From: Nesco, Susan
Sent: Monday, March 8, 2021 3:35 PM
To: Kozikowski, Marek; Samolis, Joseph
Subject: FW: Comments re: 796 Saybrook Road
Attachments: RESPONSE TO S AND W COMMENTS 3-2-21 Binder1.pdf; Sewer _Water Comments2.pdf

Re: SPR 2021-23
Rino Mozzicato
796 Saybrook Road
Proposed Medical Facility
Site Plan Dated: 02/23/2021

**SITE PLAN REVIEW
PUBLIC WORKS DEPARTMENT**

SPR 2021 -23 Saybrook Road

DRAWING NO. :
S-2

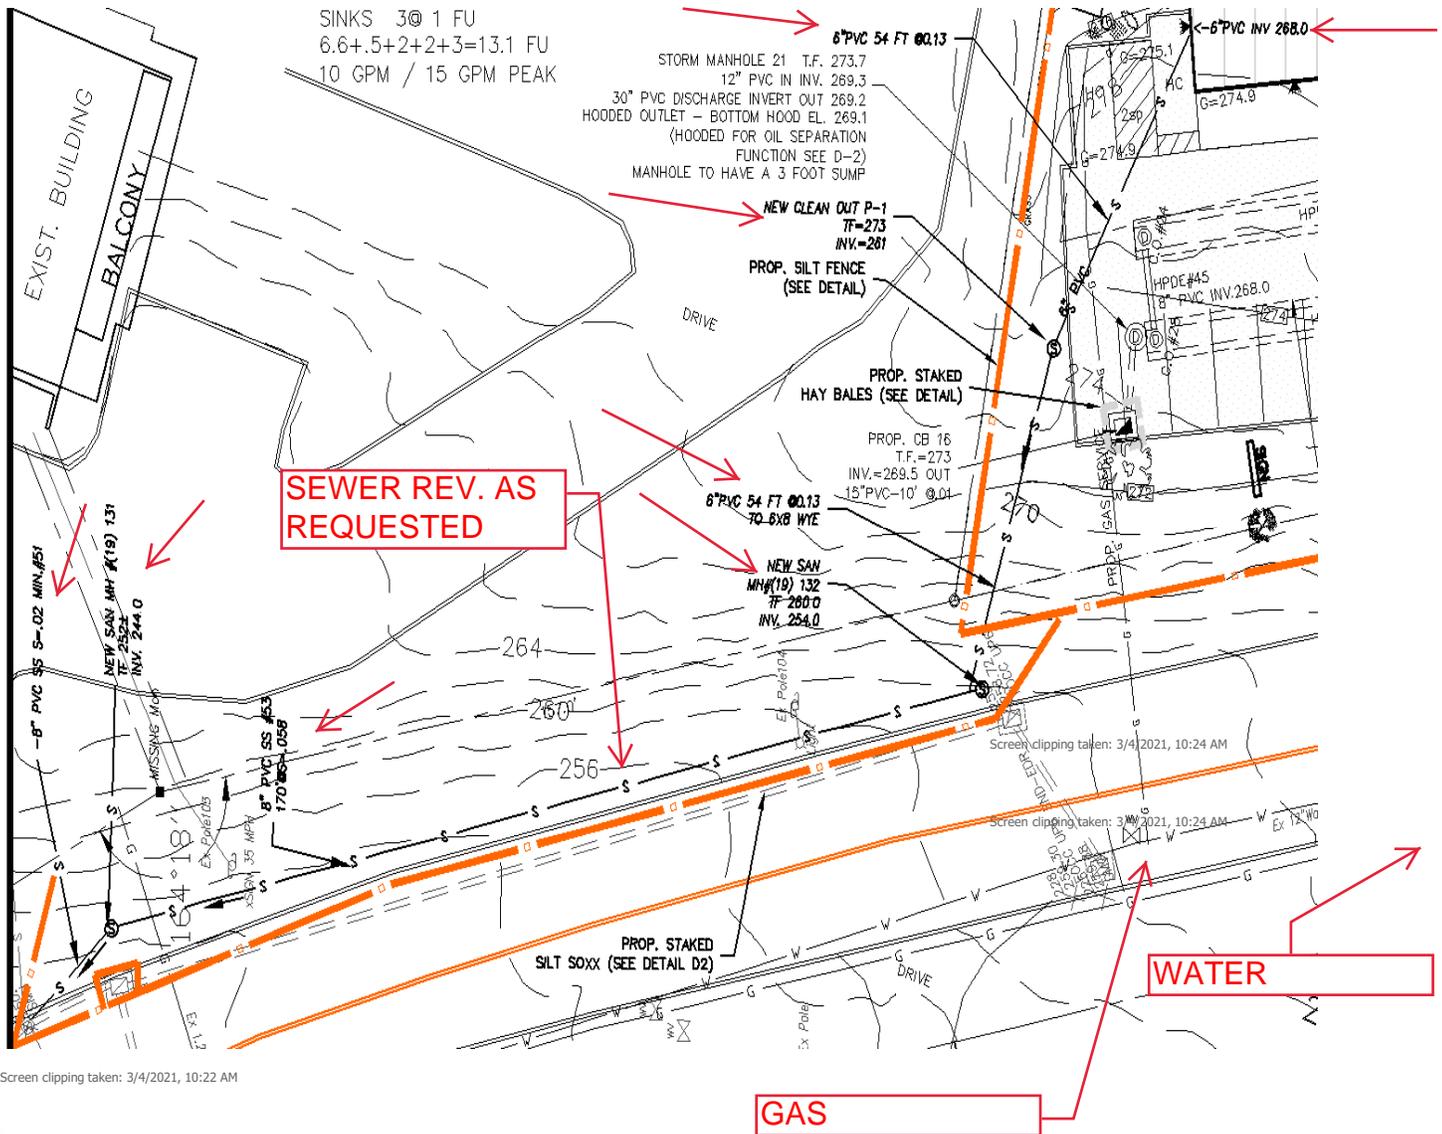
- Show the slope and pipe material of all the sewer pipe proposed on the site plan. ✓
- Maintain 5 feet minimum separation between water service and gas pipes. ✓
- Provide the proper vertical distance (18 inches minimum) between water service pipe and sewer lateral. The water service shall be above the sewer lateral. ✓
- Provide the inverts and top of frame for manhole #56 and invert at proposed building. ✓

- Connect sanitary sewer lateral to sewer main not the manhole.

The Low Pressure Sewer System specifications shall be followed for any grinder pump application.

Re-label existing manhole “MH (19) 123.” ✓

Re-label proposed manholes in City R.O.W “MH (19) 131” and “MH (19) 132.” ✓

Label private manhole/cleanout “P-1” ✓

Proposed tree should be located away from sanitary lateral and manhole. ✓

REVISION: 2 3-3-2021 S&W COMMENTS

WATER AND SEWER DEPARTMENT REQUIRES ALL CONNECTION FEES BE PAID PRIOR TO START OF UTILITY INSTALLATION.
Utilities Disclaimer:
~~The underground utilities shown have been located from limited field survey information and existing drawings. The surveyor makes no guarantee that~~
